ZONING CHANGE REVIEW SHEET

CASE: C14-2024-0180 (1211 East 52nd Street Zoning) DISTRICT: 4

ADDRESS: 1211 East 52nd Street

Figure 2. Conceptual Site Driveways (Figure taken from ZTA report); Driveways A, B, C, D are for site access. Driveways 1-4 are service driveways.

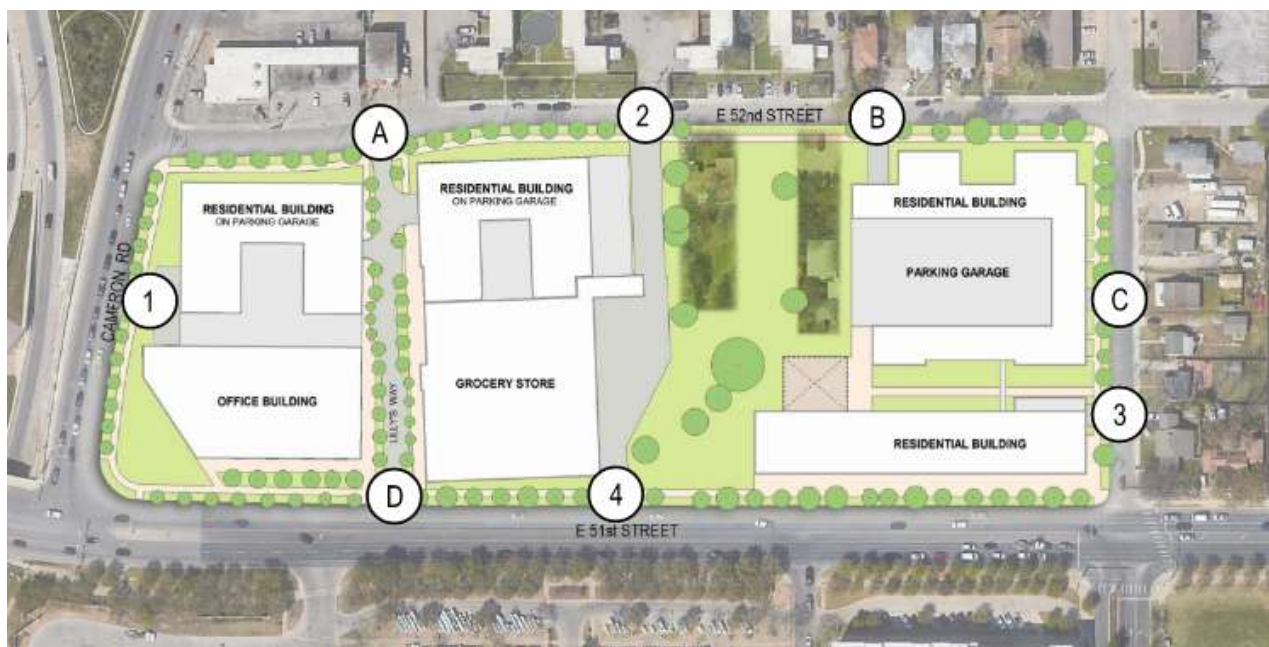
The site proposes four full purpose driveways on 52nd St (Driveways A, B), Lancaster Ct (Driveway C), and E 51st St (Driveway D). The site proposes four additional service driveway locations on (1) Cameron Rd, (2) 52nd St, (3) Lancaster Ct, and (4) E 51st St. A conceptual site plan showing proposed driveway locations can be seen in Figure 2.

3. Provide no more than two site and one service driveways on E 52nd St (designated driveways A, B, 2). The driveways are proposed to operate as full purpose and will be reviewed for compliance to City codes and ordinances at the time of the Site Plan application.

1. Provide no more than one site and one service driveway on E 51st St (designated driveways D, 4). Both driveways are proposed to operate as full purpose and will be reviewed for compliance to City codes, ordinances, criteria manual, etc. at the time of the Site Plan application.

2. Provide no more than one service driveway onto Cameron Rd (designated driveway 1), provided it can meet design requirements and does not require a waiver from the Transportation Criteria Manual (TCM). The driveway is proposed to operate as full purpose and will be reviewed for compliance to City codes and ordinances at the time of the Site Plan application.

4. Provide no more than one service driveways on Lancaster Ct (designated driveways C,3). The driveway is proposed to operate as full purpose and will be reviewed for compliance to City codes and ordinances at the time of the Site Plan application.
